SUBJECT:
Davis-Besse Nuclear Power Station, Unit No. 1
Docket No. 50-346, License No. NPF-3
Submittal of Pressure and Temperature Limits Report, Revision 5

Pressure and Temperature Limits Report for Up to 43.5 Effective Full Power Years,
Revision 5

Revision 5

Figure 1: Reactor Coolant System Pressure-Temperature Heatup and Criticality Limits

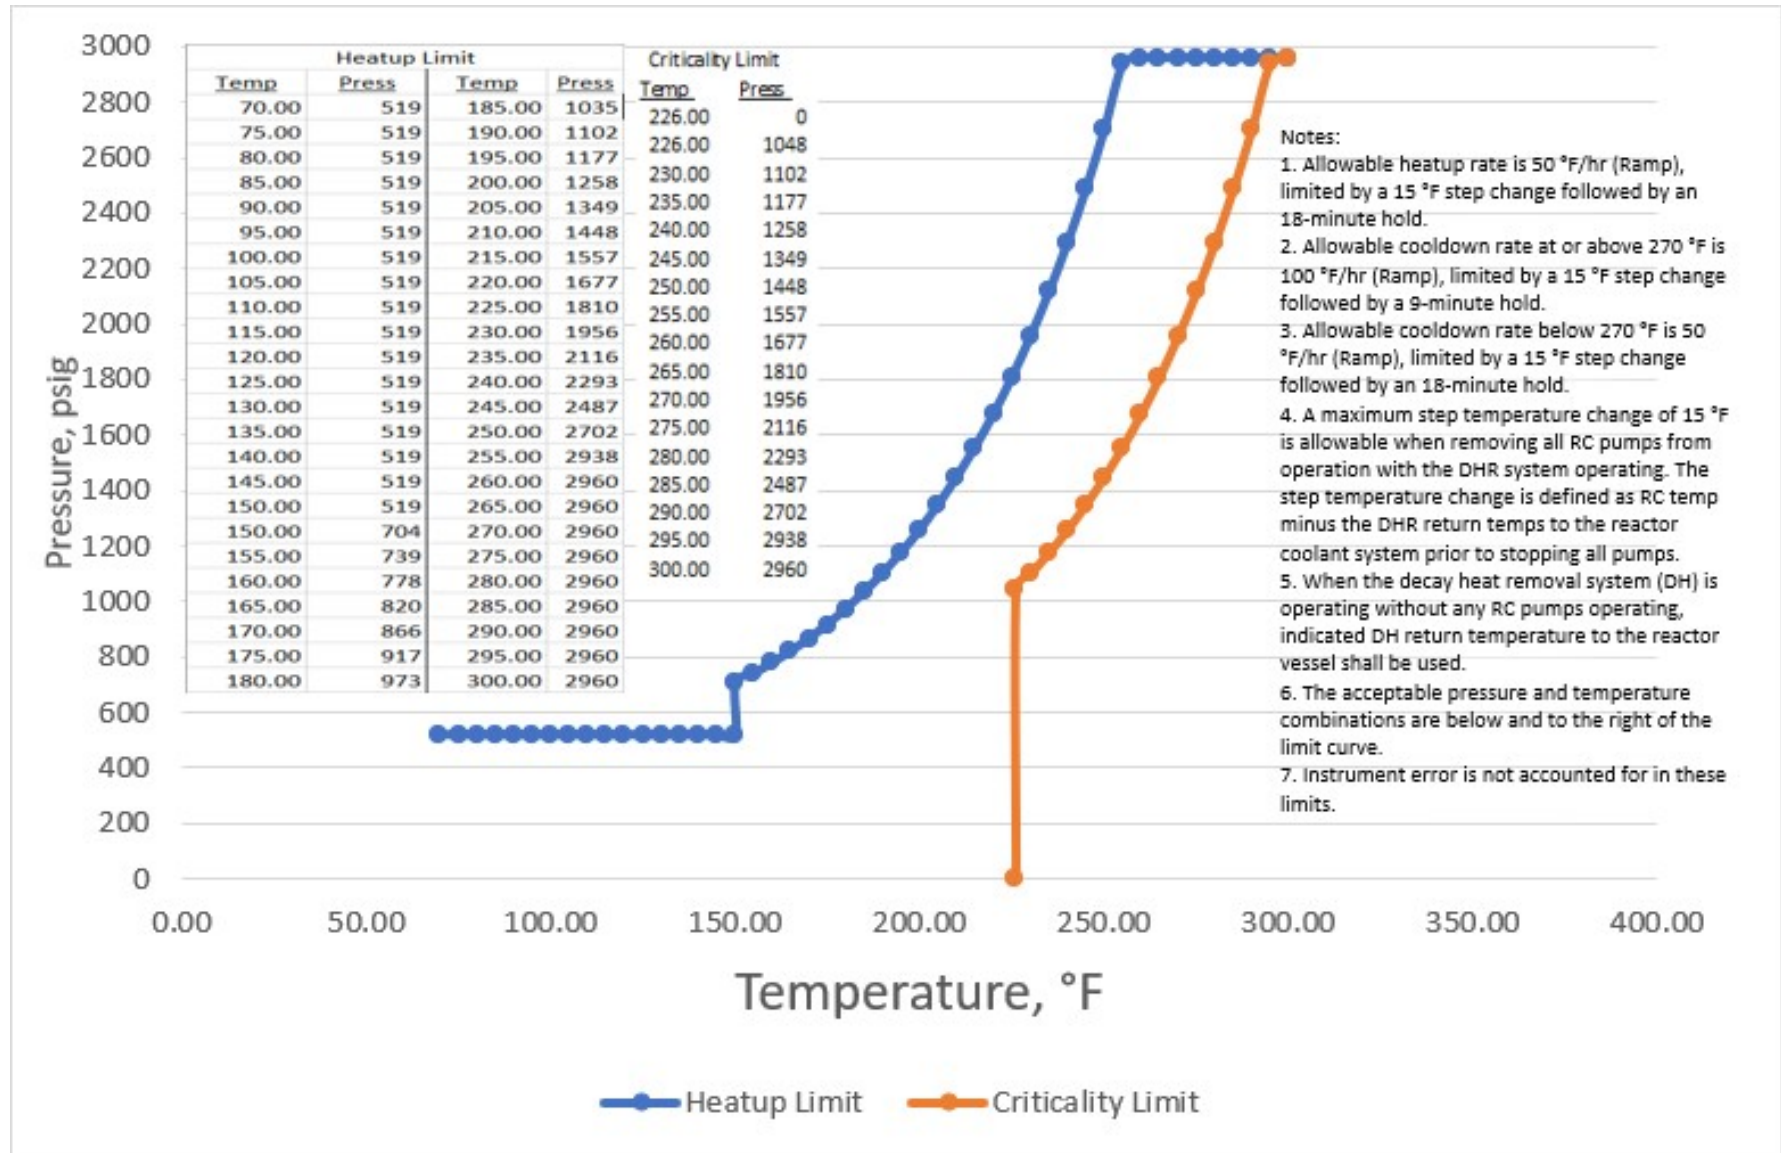
Revision 5 is re-issuing the 43.5 EFPY Pressure and Temperature Limits Report to remove two data points in Figure 1 (Heatup Limit) at 226 °F and to incorporate the correct temperature data table in Figure 2. Consistent use of units was incorporated into Section 2.0 "RCS Pressure and Temperature Limits". No methodology changes occurred in this revision.
